Z-111
(2016)

ZONING PLAN
FOR
SHALLOWFORD PLACE
LOCATED IN LAND LOT 400,
16TH DISTRICT, COBB COUNTY, GEORGIA

ZONING COMMENTS:

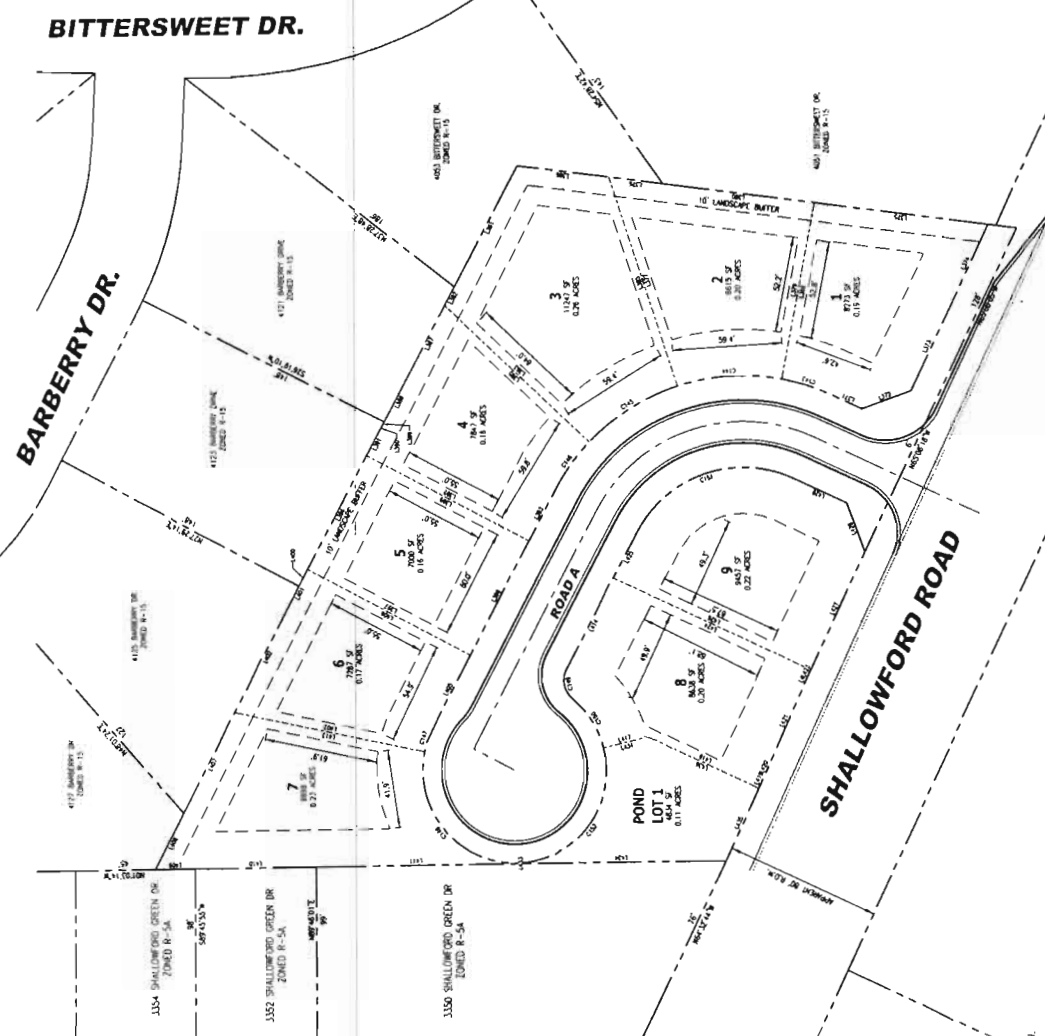
The applicant is requesting a rezoning to the RA-5 single-family residential district in order to develop nine (9) detached single-family homes. That district’s minimum lot size of 7,000 sq. ft. will be met with the lots ranging from 7,000 sq. ft. to 11,247 sq. ft. The proposed homes will be a minimum of 2,500 square feet and be constructed with brick, stone, stacked stone, cedar shake, board and batten, or combinations thereof. Anticipated selling prices will be starting in the high \$500,000s. The Code-required 10 foot landscape buffer is provided adjacent to more restrictively zoned (R-15) properties.

1. Waive the rear setback from the required 40 feet to 20 feet with an increase of the front setback from the required 20 feet to 25 feet.

GUEST PARKING: When projects contemplate less than 20 foot separation between units, guest parking shall be provided at a ratio of one-half space for each dwelling unit (1 space/ 2 units).

- No Stormwater controls shown _____
- Copy of survey is not current – Additional comments may be forthcoming when current site conditions are exposed.
- No site improvements showing on exhibit.

1. This site is located just north of Shallowford Road and is bounded on the north and east by Hedgerow Subdivision and on the west by Shallowford Green Subdivision. Slopes on the site are relatively mild ranging from 2 to 10%. The majority of the site (2/3) drains to the Shallowford Road R/W. The remaining third drains to the east into the Hedgerow Subdivision Recreation Area.
2. Any bypass runoff from the rear of lots 1 through 7 must be directed to the Shallowford Road right-of-way and not to the Hedgerow Rec Area.

Shallowford Road is classified as an arterial and according to the available information the existing right-of-way does not meet the minimum requirements for this classification.

Recommend applicant consider entering into a development agreement pursuant to O.C.G.A. 36-71-13 for dedication of the following system improvements to mitigate traffic concerns: a) donation of right-of-way on the north side of Shallowford Road, a minimum of 50' from the roadway centerline.

Recommend curb and gutter along both sides and sidewalk along one side of proposed development roadway.

Recommend guest parking be located outside of the right-of-way.

1. Site plan received by Zoning Division on October 6, 2016 with District Commissioner approving minor modifications;
2. Fire Department comments and recommendations;
3. Water and Sewer Division comments and recommendations;
4. Stormwater Management Division comments and recommendations;
5. Department of Transportation comments and recommendations;
6. Owner/developer to enter into a Development Agreement pursuant to O.C.G.A. §36-71-13 for dedication of system improvements to mitigate traffic concerns; and
7. House architecture to be approved by the District Commissioner.
